OGLE PETROLEUM INC.

September 15, 1980

RE: Commercial Source Material  
License Application, Docket  
No. 40-8745

URANIUM RECOVERY PLAN SCHEMATIC DIAGRAM

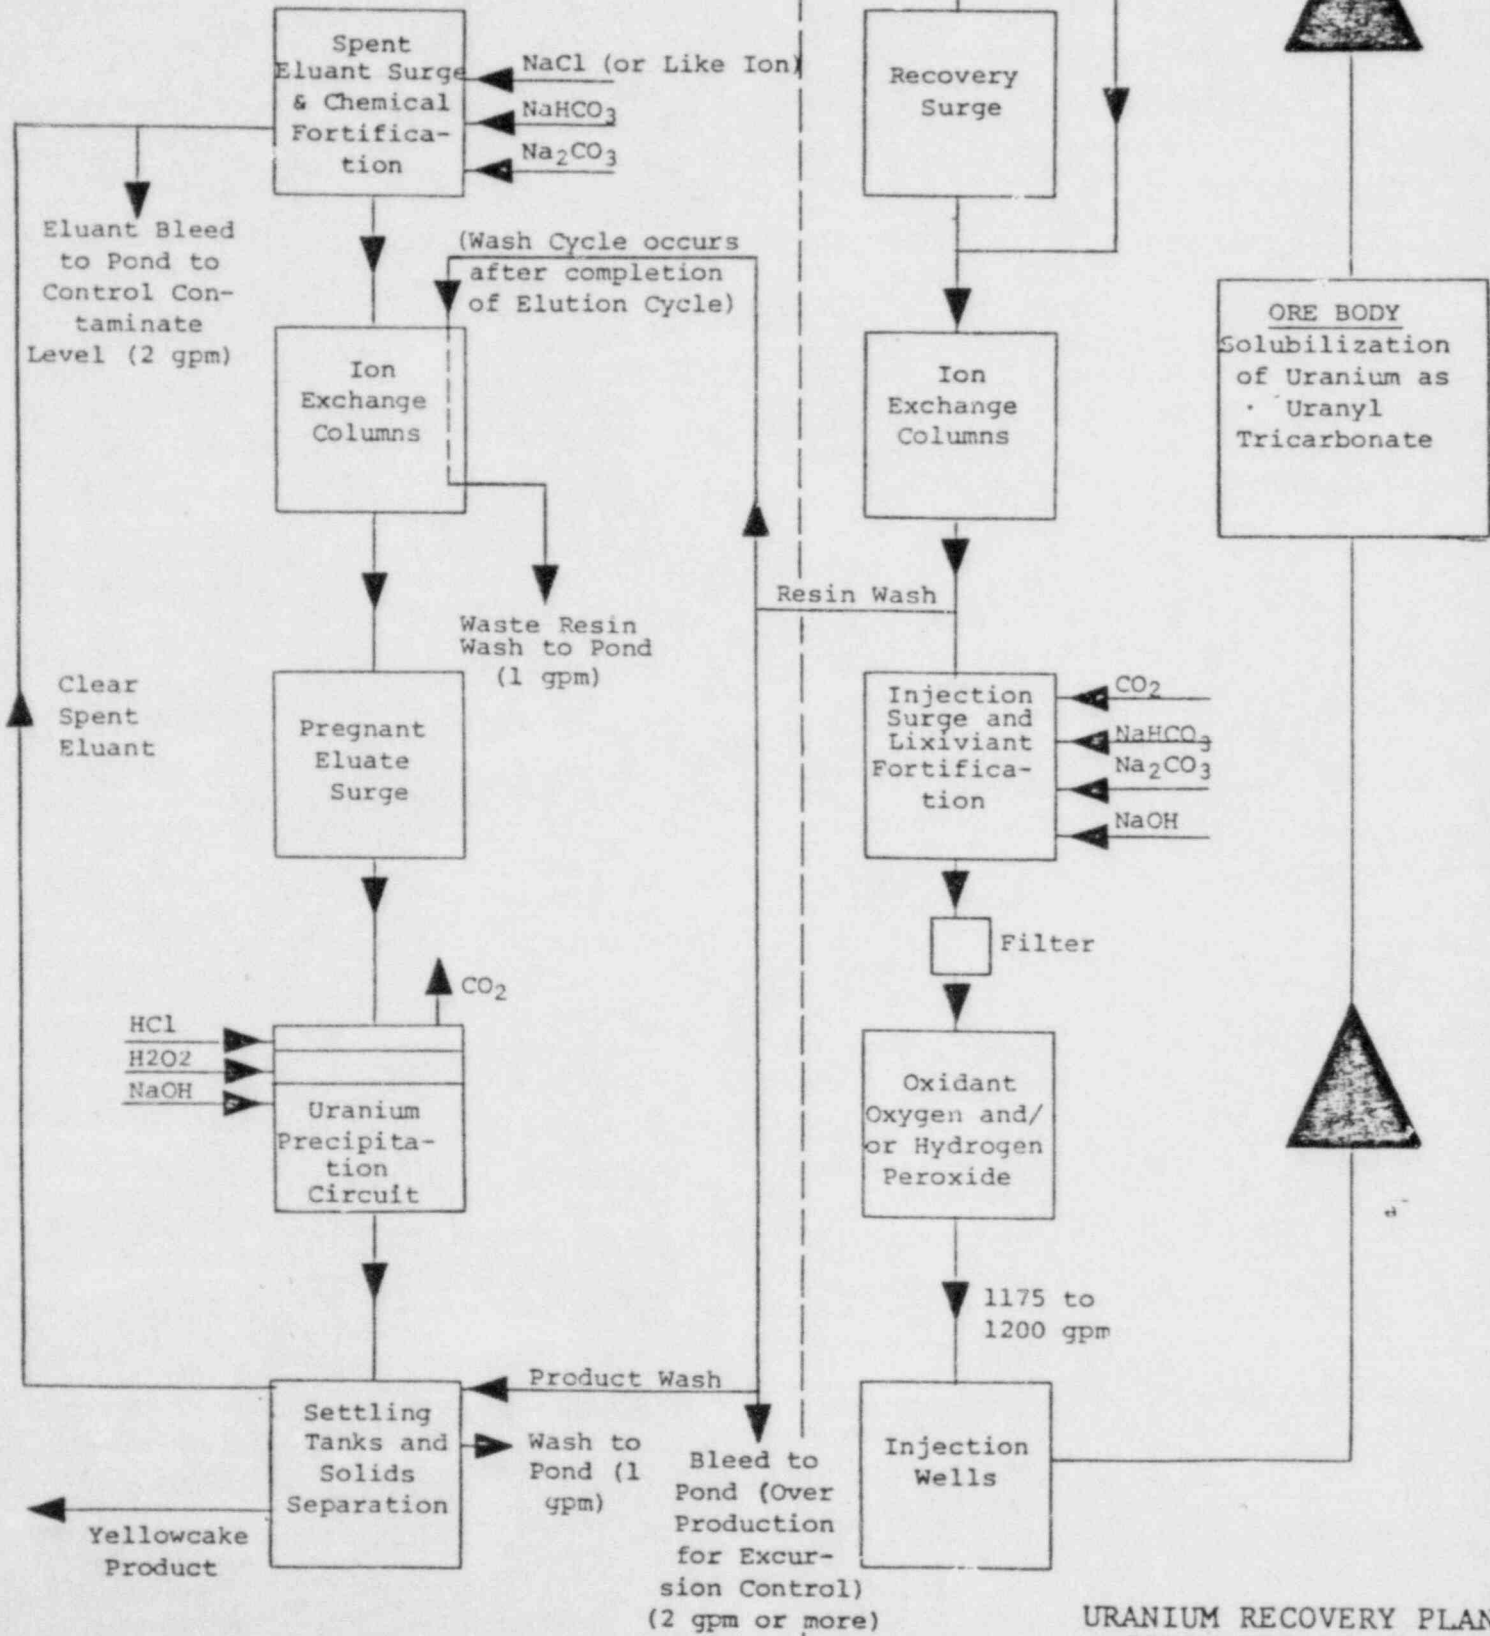
13. Page 2-31, Section 2.3.10.2, Elution Circuit.

OPI has made a minor design change in the elution circuit. Originally, it was planned to transfer resin between the loading (adsorption) columns and the elution columns. OPI now plans on using expanded bed ion exchange columns and eluting in-place with no transfer of resin between ion exchange columns. In view of this change, it is suggested that paragraph number 2 of the above referenced subsection be rewritten as follows:

Enclosed is revised Figure 2.8 (page 2-30 of the DES) that incorporates the above mentioned changes.

The Bison Basin Project will use expanded bed ion exchange columns. As a column becomes loaded with uranium, it will be eluted in place. No transfer of resin between columns will take place. The elution step reverses the ion exchange reaction, forcing the uranium from the resin and replenishing the resin with a replacement ion such as chloride or another similar ion. After a column is eluted, the resin is rinsed and the column is again ready to begin loading uranium. The rinse solution is discharged to the evaporation pond.

The solution leaving the column that is being eluted contains uranium

The fresh eluant is then ready for recycling to the next ion exchange column to be eluted.
